Product Change Notice (PCN)

PCN Number: PCN-0450965R-01

Product(s) Affected: *MJ1-2503A*

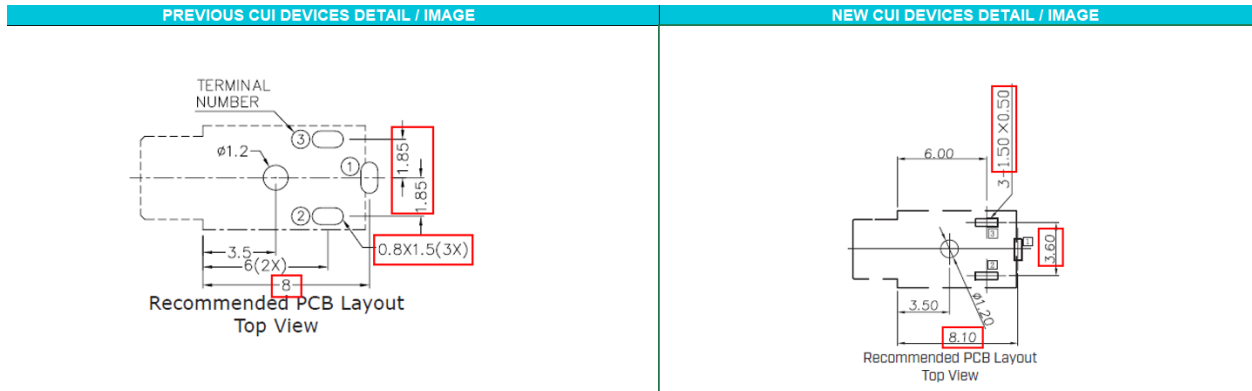
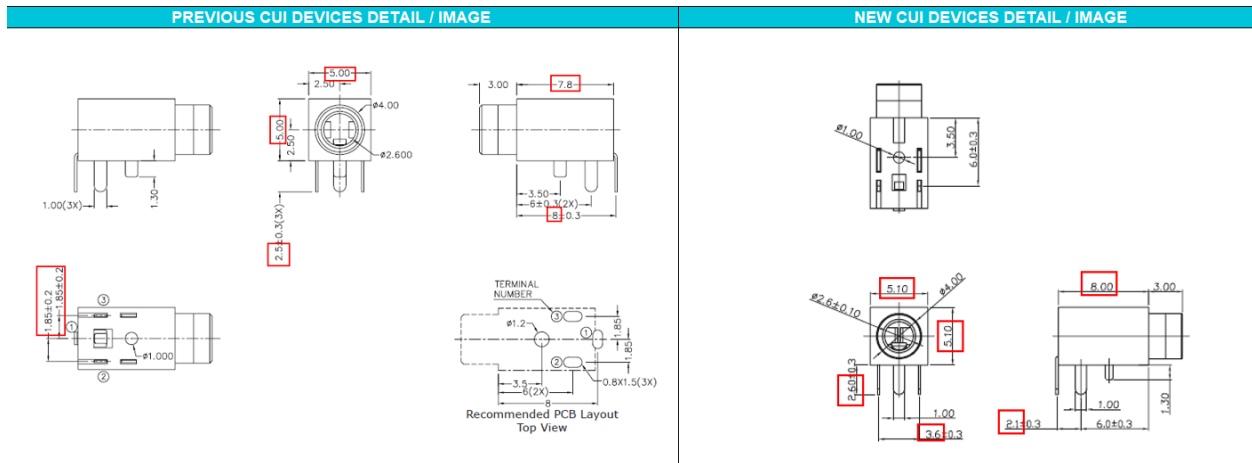
Description of Change: *Minor Layout and Material Difference. See image Below*

PREVIOUS CUI DEVICES DETAIL / IMAGE			NEW CUI DEVICES DETAIL / IMAGE		
	MATERIAL	PLATING			
terminal 1	copper alloy	silver	terminal 1	bronze	silver
terminal 2	copper alloy	silver	terminal 2	bronze	silver
terminal 3	copper alloy	silver	terminal 3	bronze	silver
bushing	brass	nickel	bushing	brass	nickel
plastic	PBT		housing	PBT (UL94V-0)	black
